ADDENDUM 2

CSP 22-68

Memorial Middle School Heating & Air Condition (HVAC) Improvements Funded through the Elementary & Secondary Emergency Relief (ESSER) Funds

April 8, 2022

SHEET NUMBER: **E4.01**

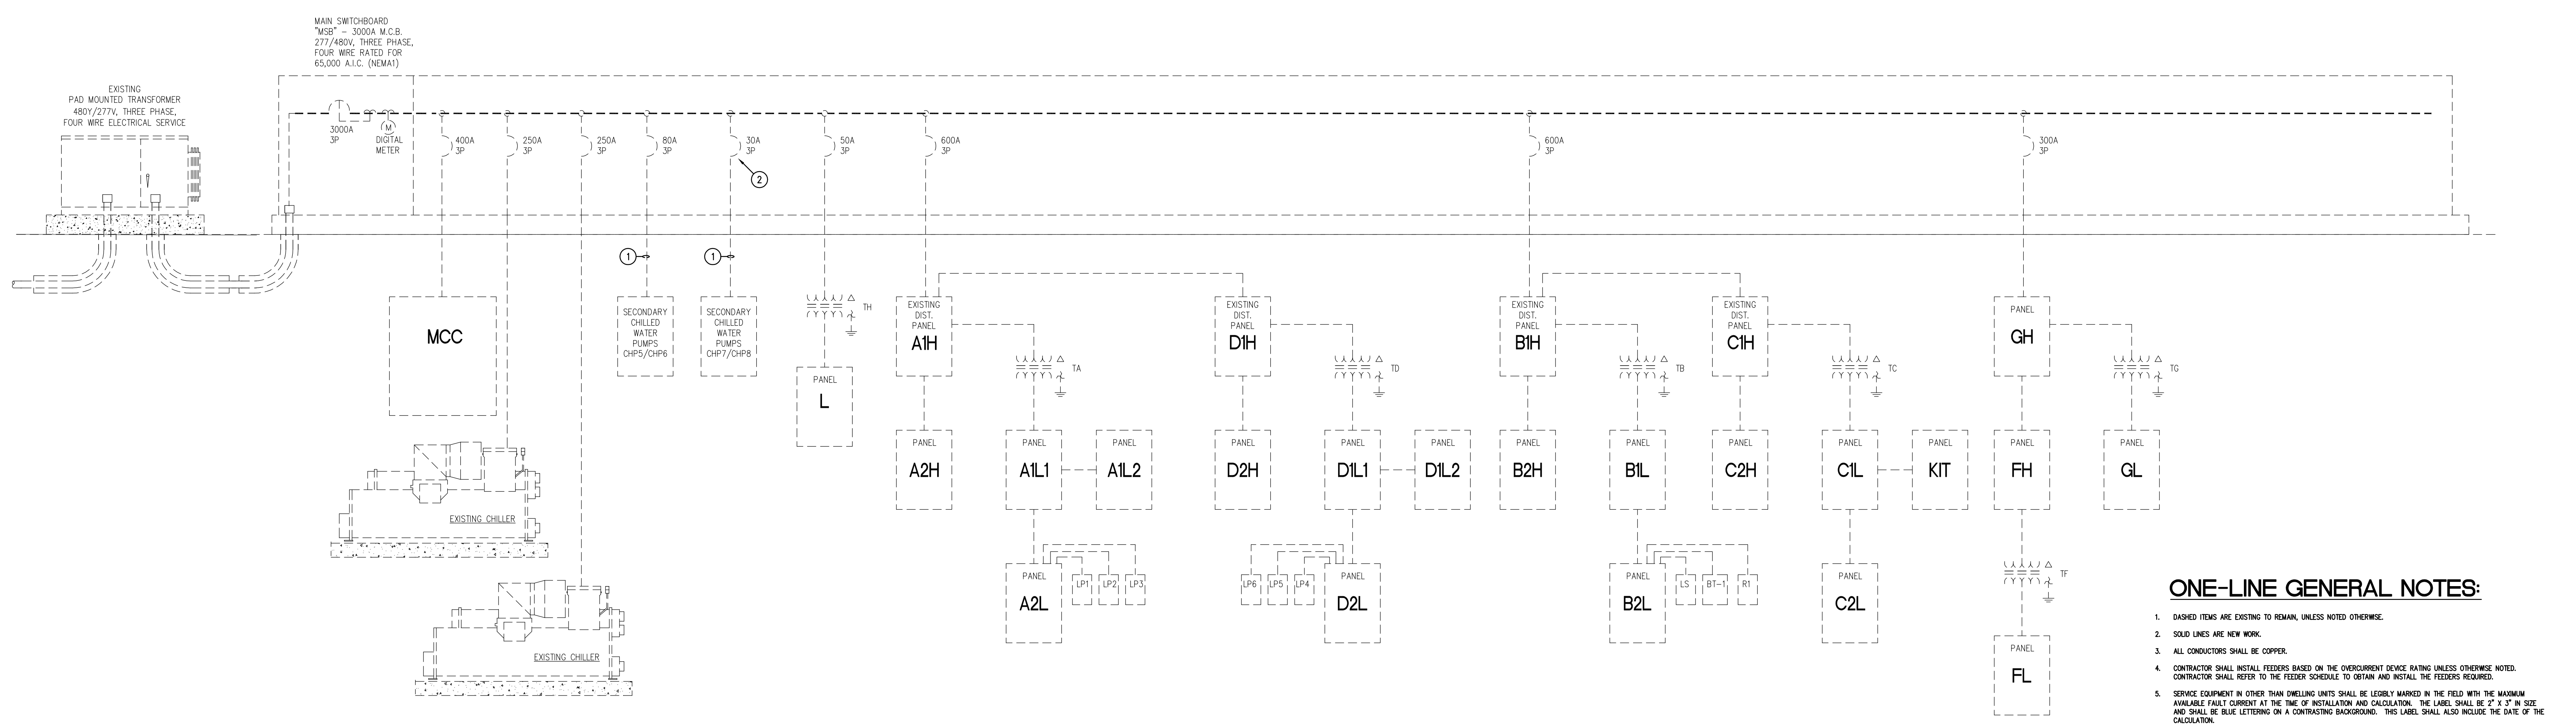
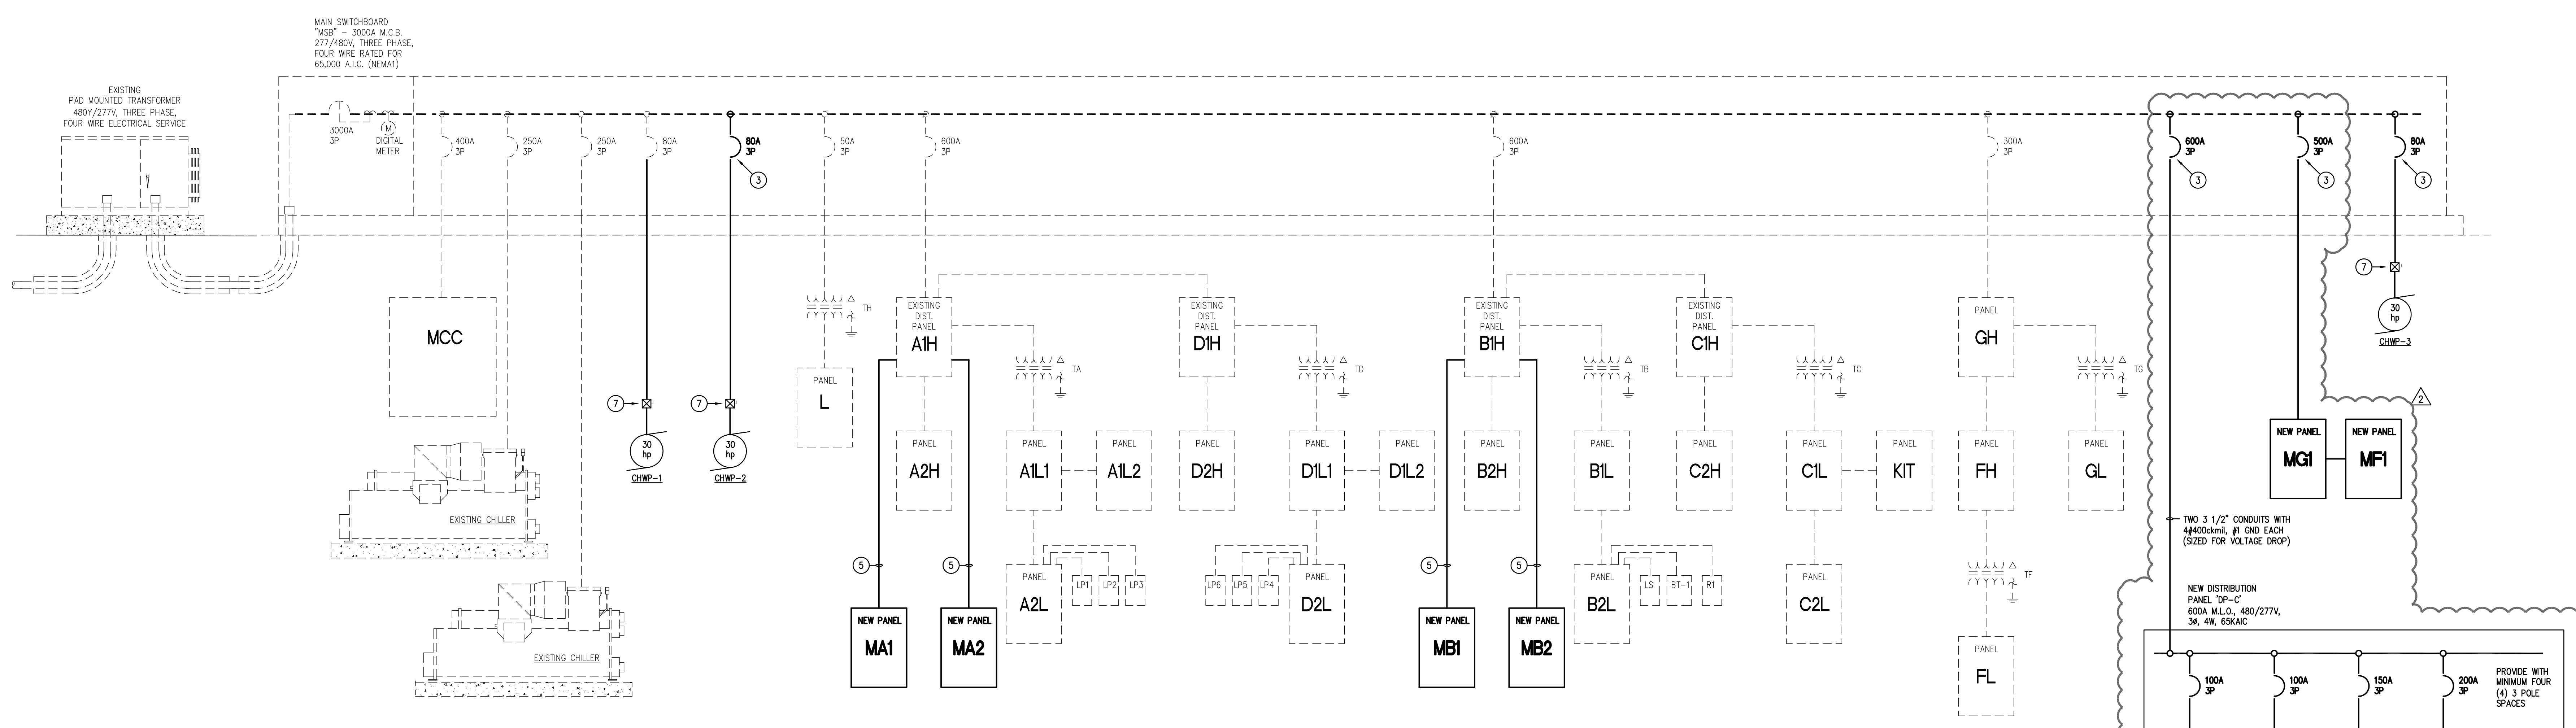
Item 23 SHEET E4.01 – ELECTRICAL ONE-LINE DIAGRAM

A. Added distribution panel DP-C.
B. Revised the feeding of branch circuit panels MC1, MC2, MD1, MD2, MF1 and MG1.
